# Addendum 04

**PROJECT:** Fort Loramie Local Schools Athletic Complex Building & Associated Improvements  
600 East Park Street  
Fort Loramie, Ohio 45845

**PROJECT #:** 25041.00

SHEET NUMBER:  
**E7.1**

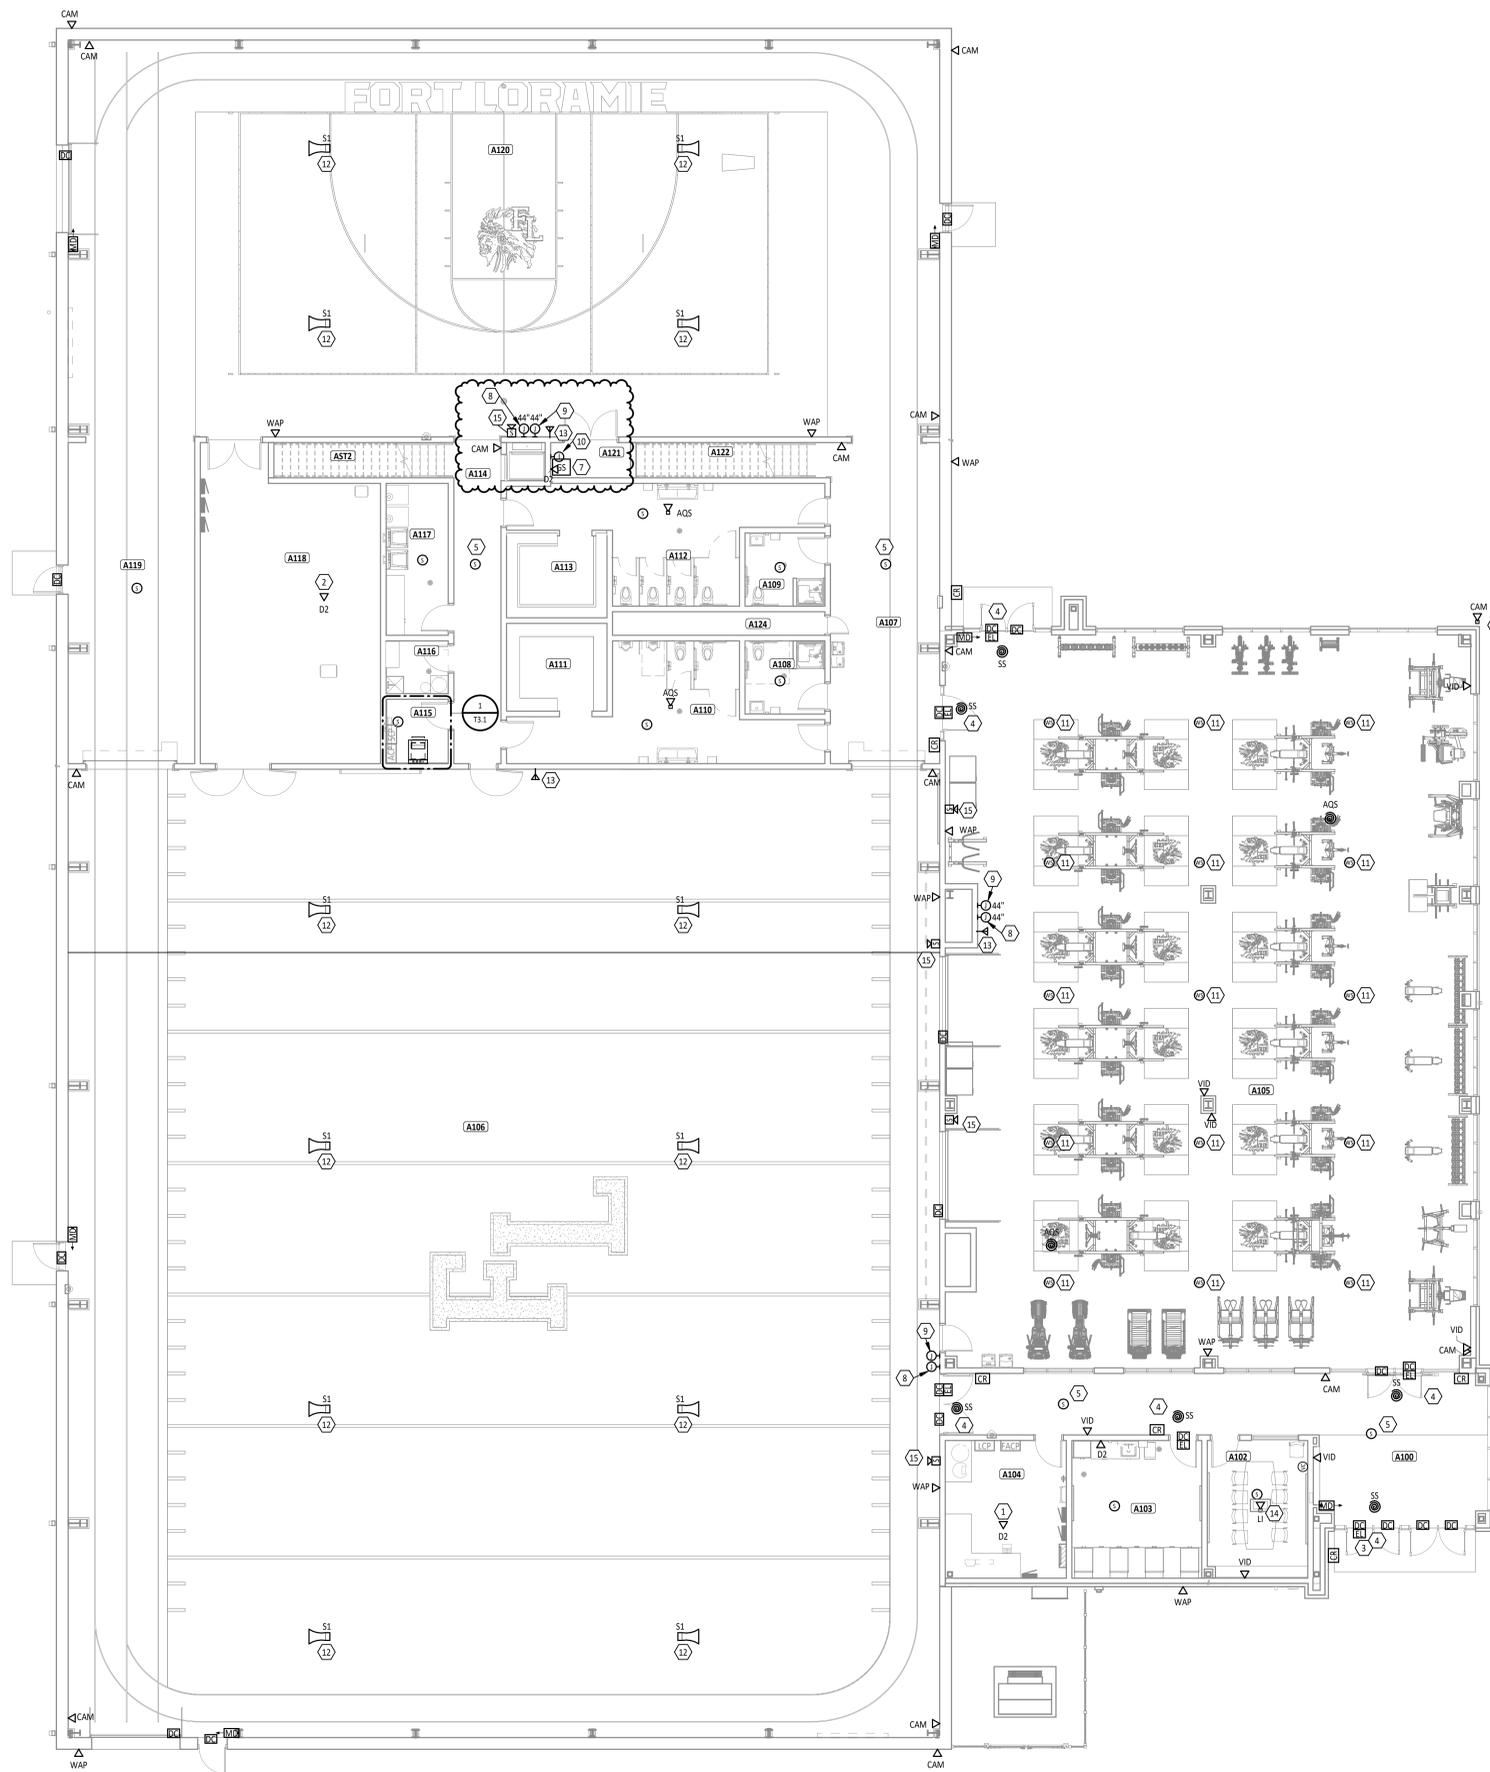
21. E7.1 – Luminaire Schedule
  - a. Fixture X1 – Provide mounting height instruction.
  - b. Provided lighting equals.
22. E8.1 – Electrical One-Line Diagram and Panel Schedules
  - a. Panel Schedule B (2 of 2) – Provided a circuit for vertical lift.
23. TC1.1 – First Floor Technology Cabling Plan
  - a. Relocated Sound System Equipment in A121 to accommodate vertical lift.
